CONSERVATION COMMISSION AGENDA

Date: Thursday, Sept 1, 2022

1. 7:00 – 107 Truman Rd – NOI – partial demo and construction of a single-family home – DEP #239-935

01

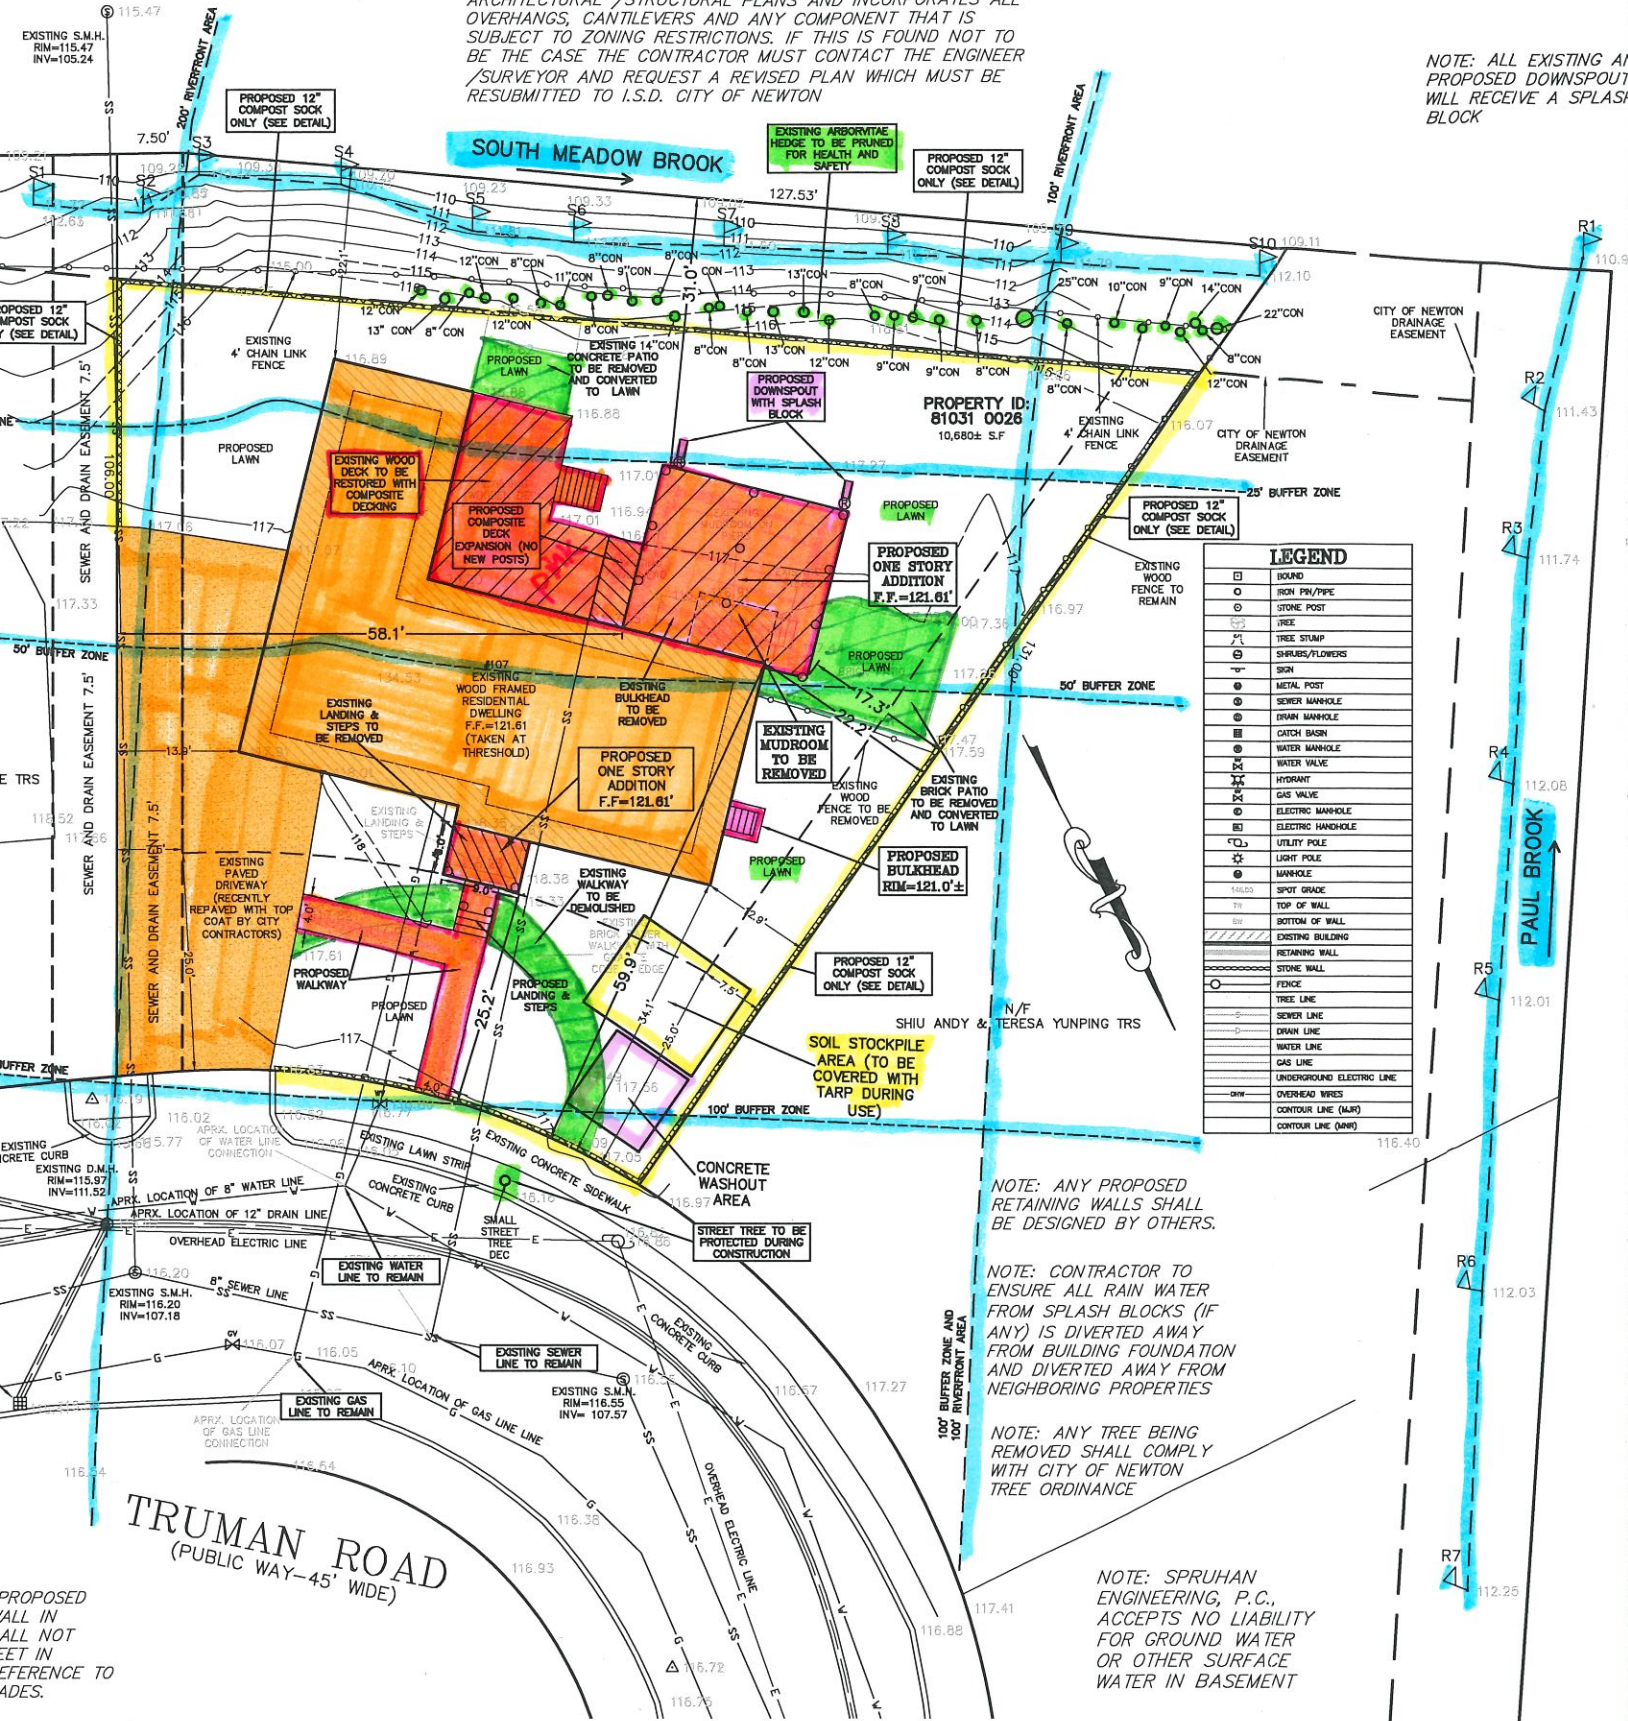
- No formal stormwater improvements are proposed.
- Staff Notes.
 - City Engineering has approved the project design as-is.
 - Project will require limited equipment and limited excavation.

- Two easements occur on property. A sewer/drain easement and a drain easement.
 - Property has a large driveway which was recently repaved by City. Proposed erosion on east side stops at pavement. Soil stockpile and concrete washout areas seem appropriately located on the other side of the property.

- Proposed lawn in back (conversion) could be difficult to establish due to shade.
 - Currently there are concrete spoils and exposed pipes at NE corner near South Meadow Brook.

162 Islington Rd

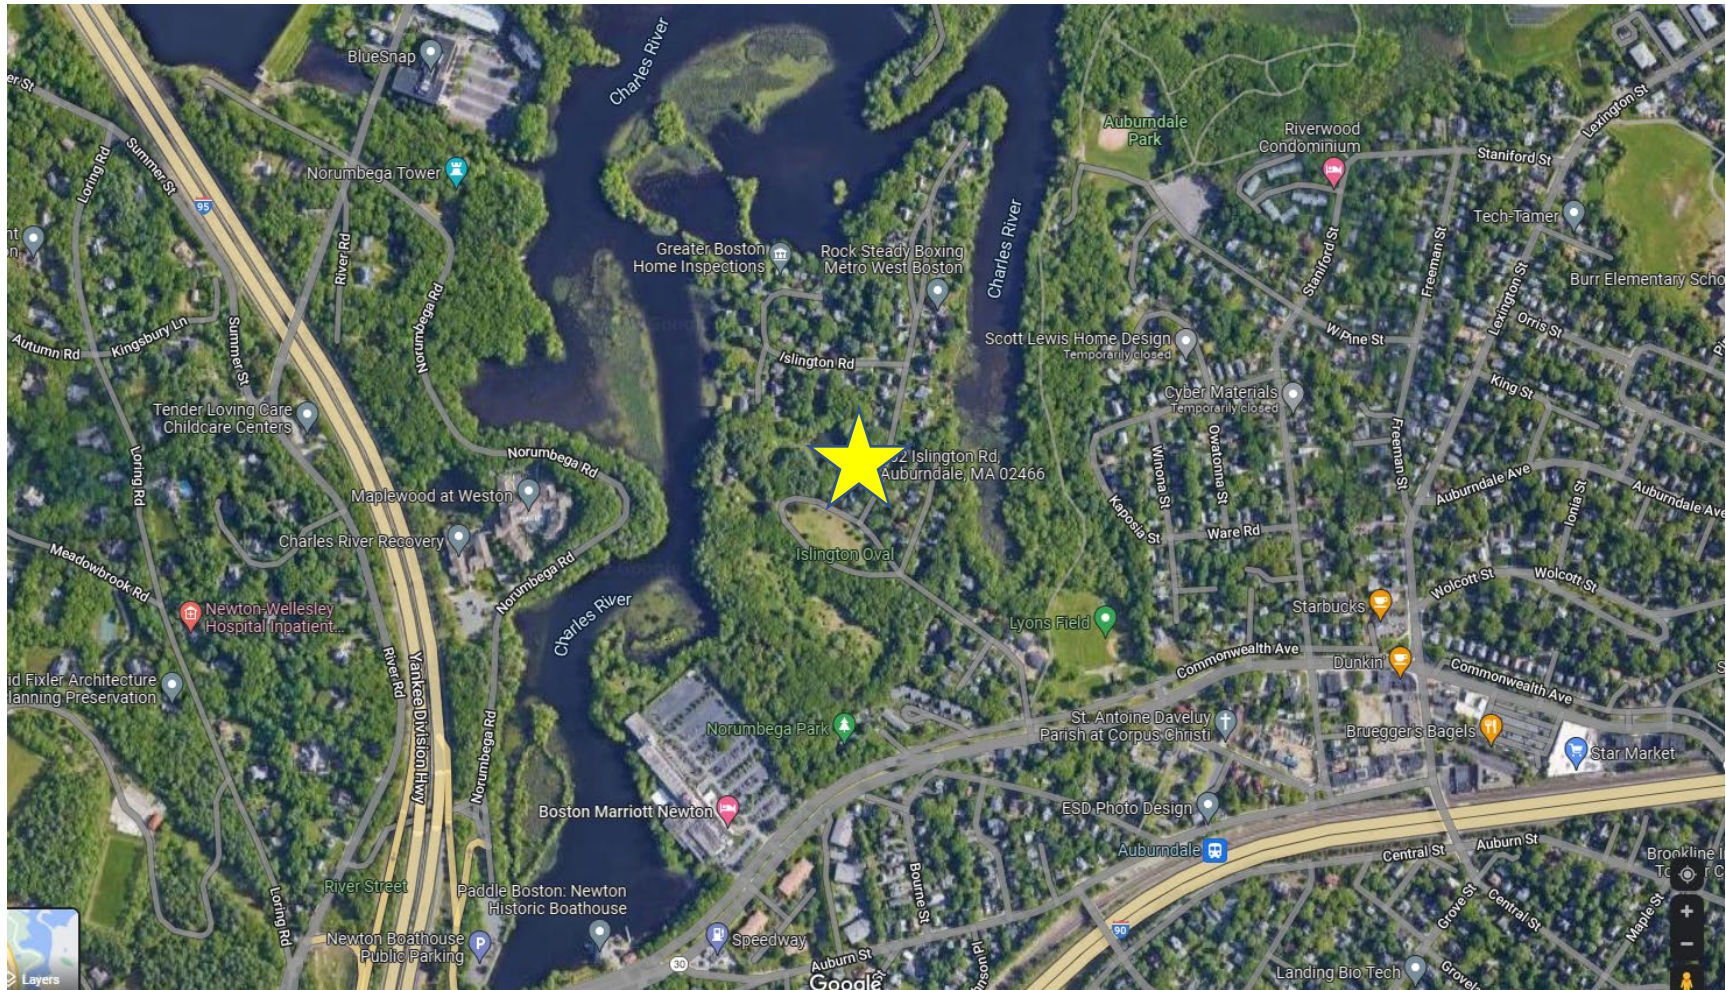
- Entrenched silt fence + compost sock would provide better erosion control.
 - A full set of landscape plans was included with application.
 - Tree protection plan and details should be provided for canopy preservation.

- Scale bar on engineering plans needs to be fixed.

518 Quinobequin Rd

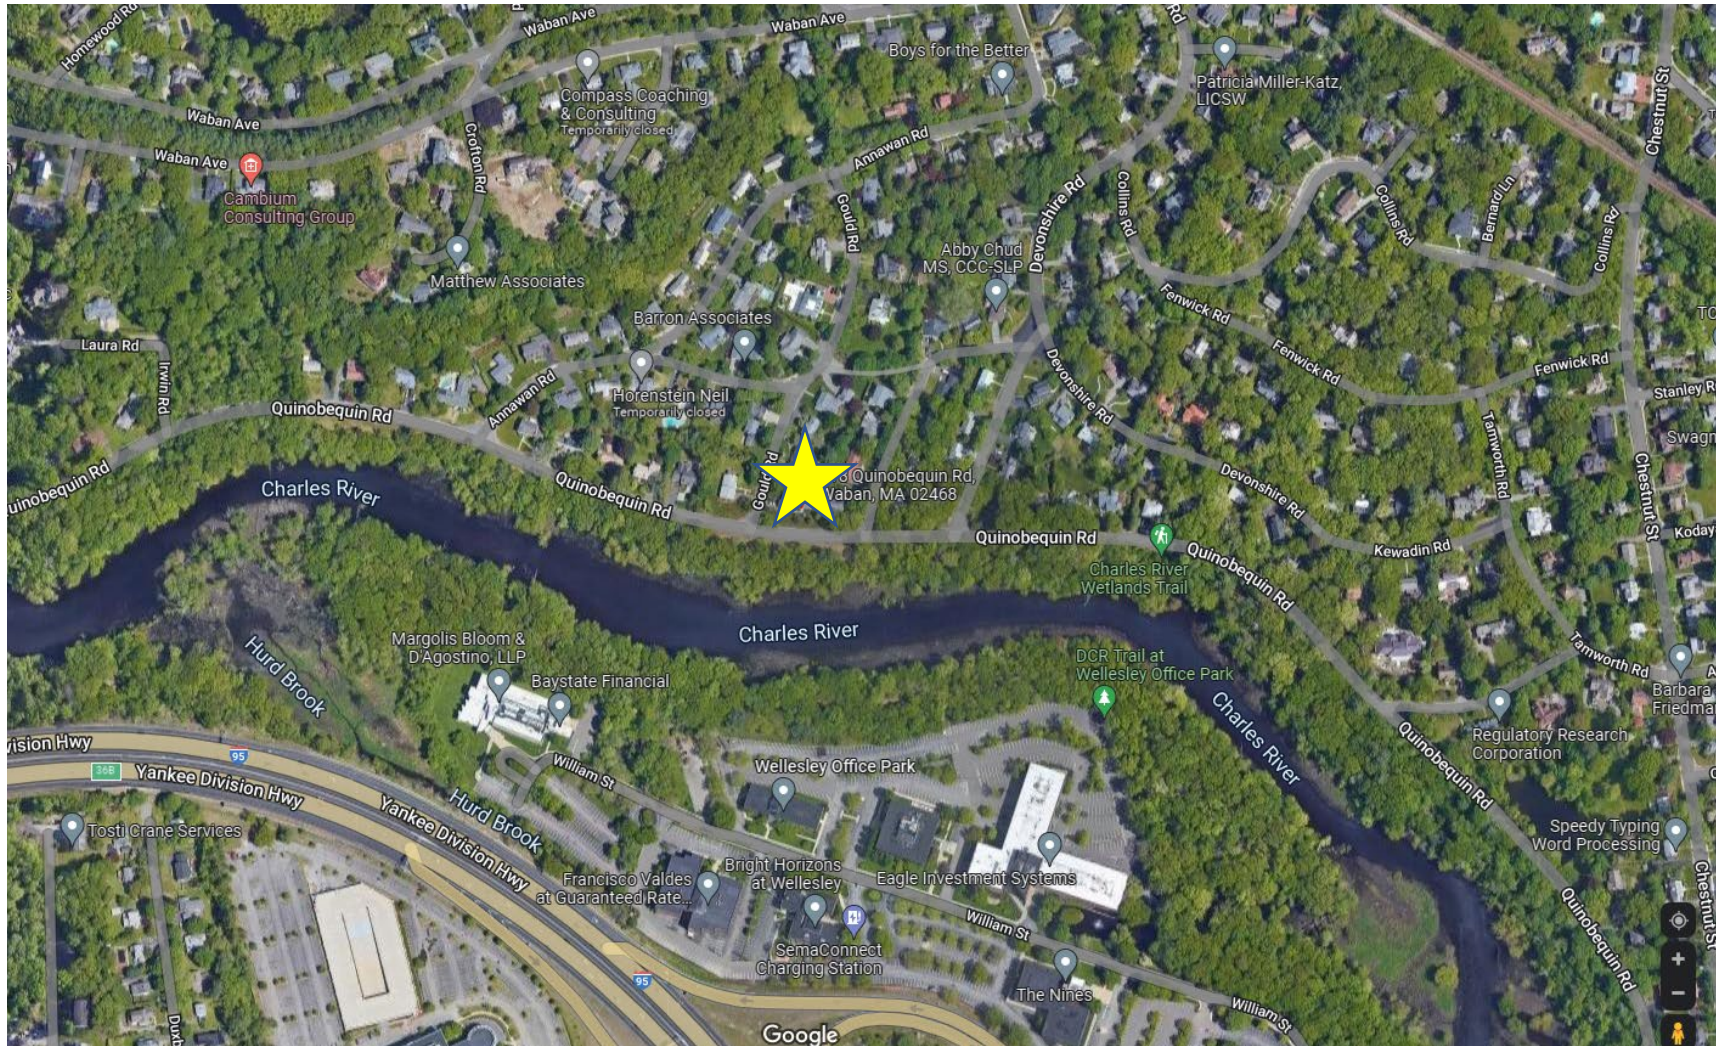
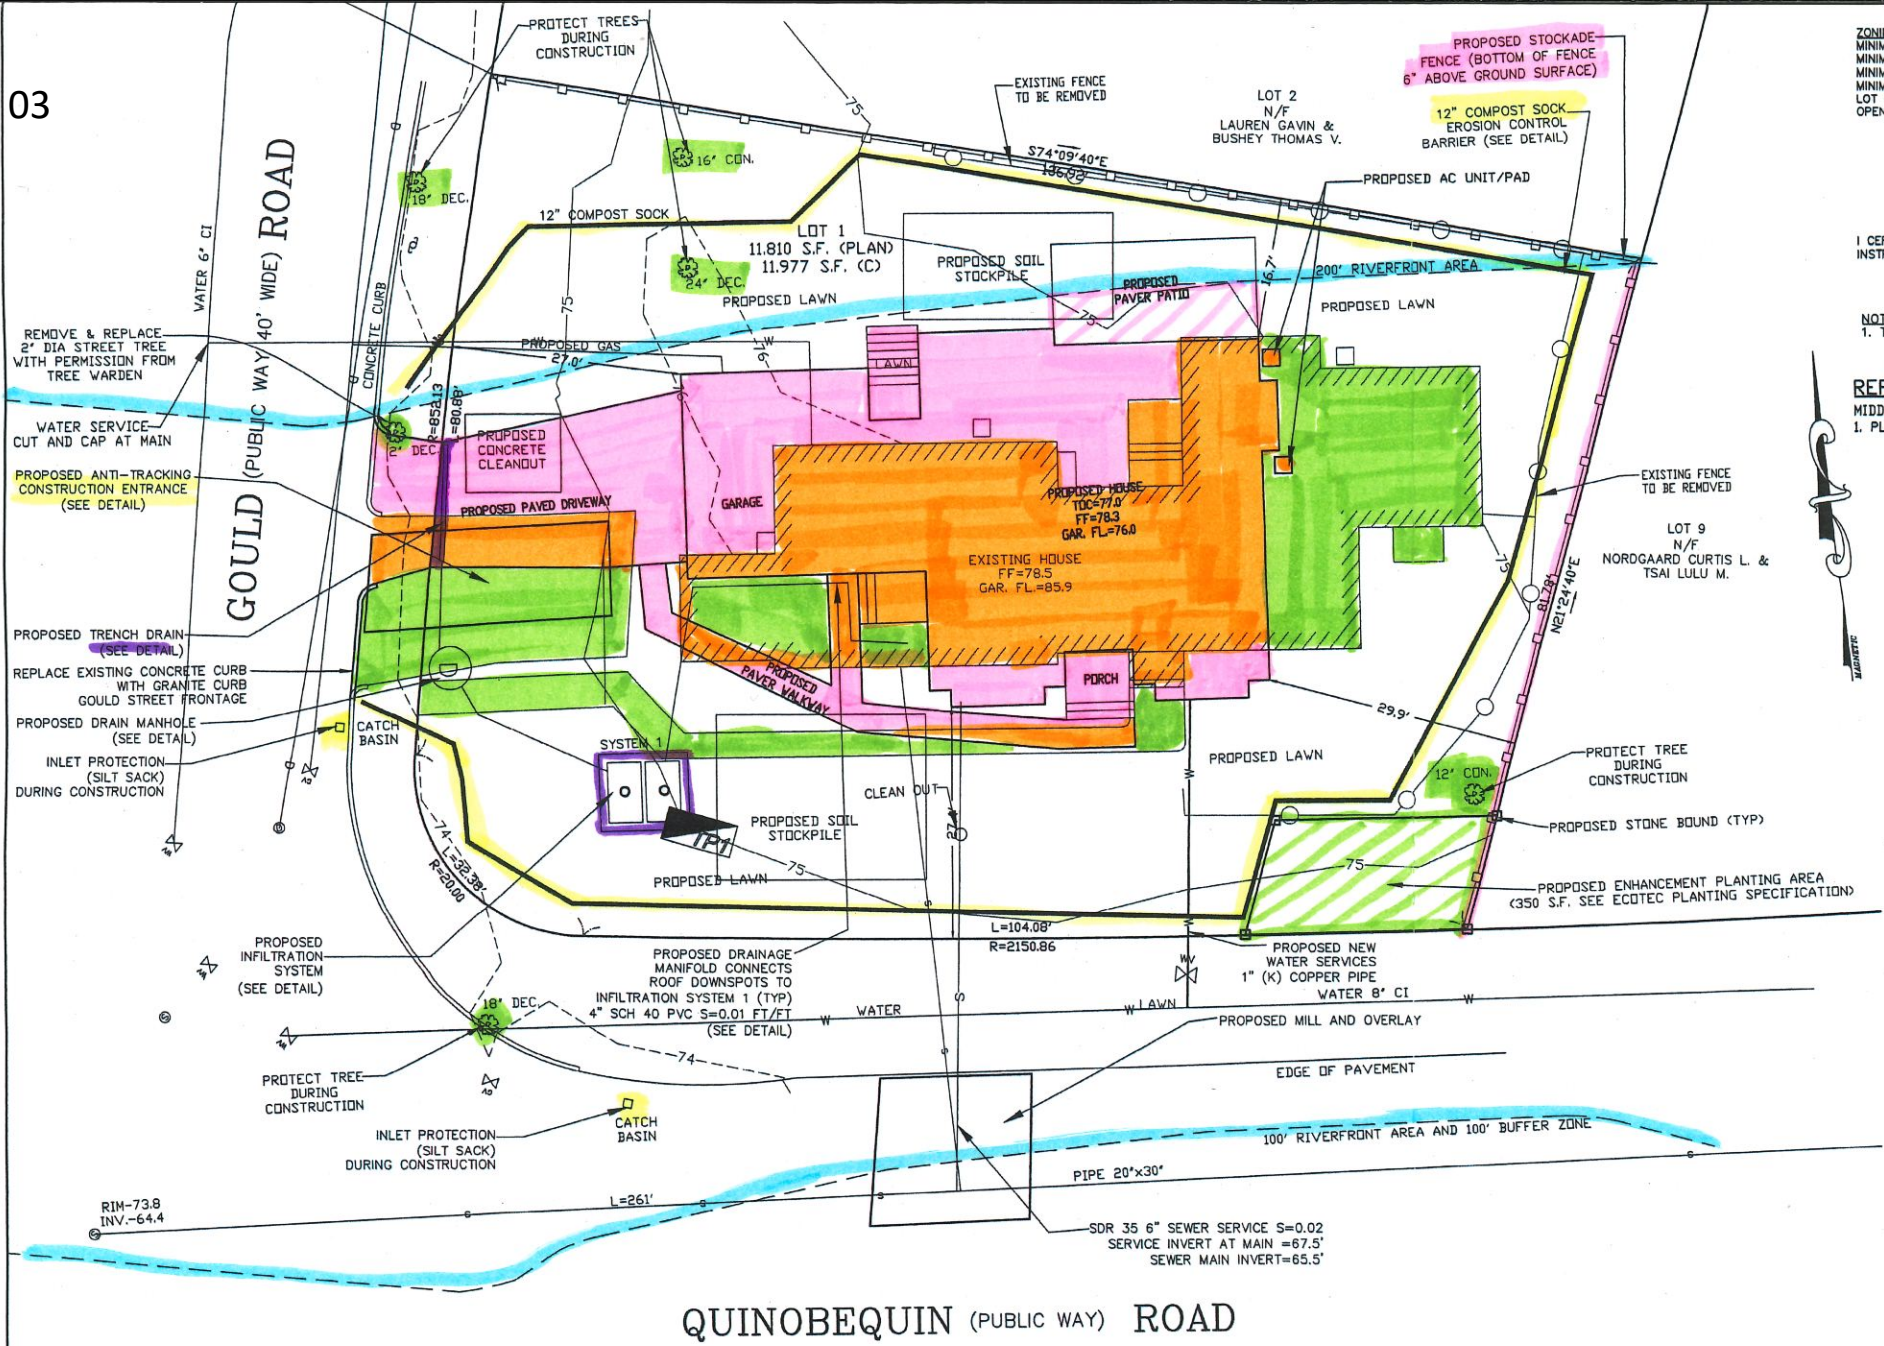
- The O&M plan has not been revised, and staff have the following comments:
 - Plan is a mixture of pre-construction, construction period, and post-construction information, which could be confusing to the landowner.

- O&M plan contains no specifics about the infiltration system (what the components are, how to inspect, what to inspect for, or how to clean).
 - Staff is still concerned about the health/safety of the 24" tree shown inside the erosion control line.

- Staff Recommendation.
 - Seek improved/detailed tree protection plan.
 - Seek modifications to the O&M plan.
 - Once all questions have been answered, vote to close the hearing and issue an OOC with the state's required conditions, Newton's special conditions, and the following site-specific special conditions:

115 Elinor Rd

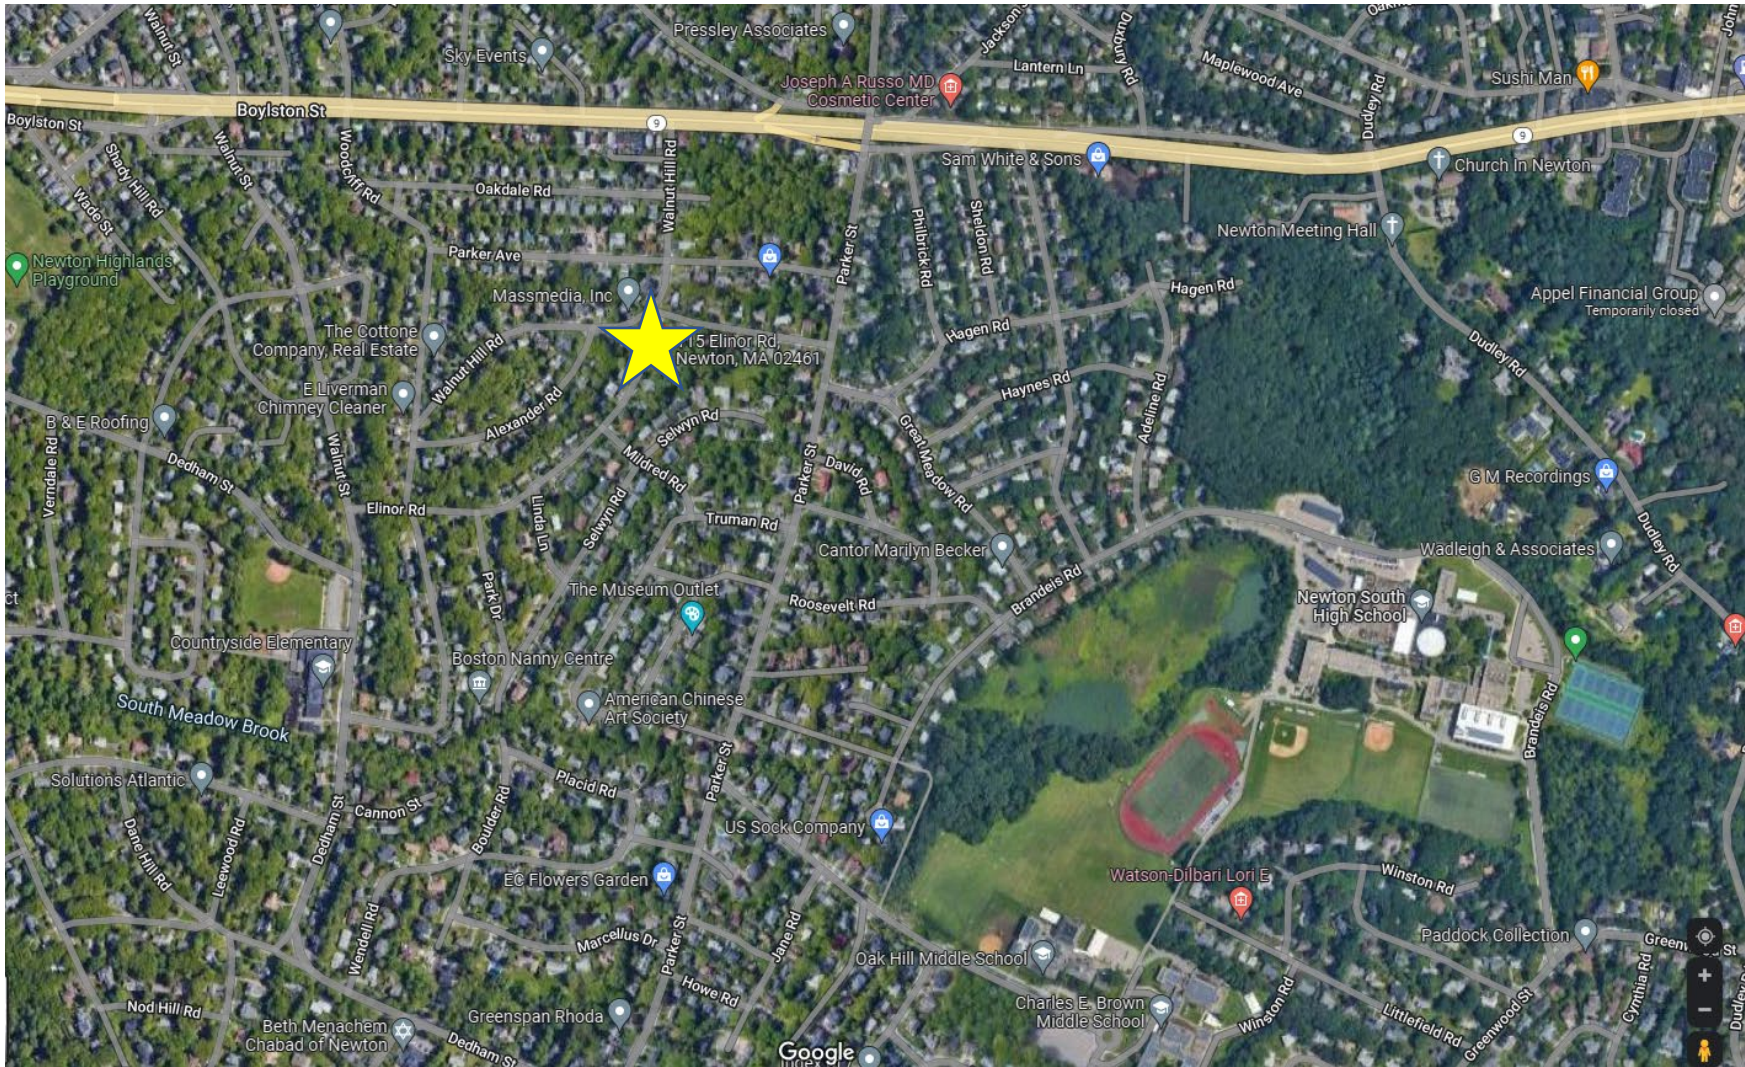
- Staff Notes.
 - One of the proposed cut/fill areas is partly outside LOW.
 - Plan needs tree removal/preservation/protection details. Property contains several mature and healthy canopy trees. Some are inside, some outside the floodplain.
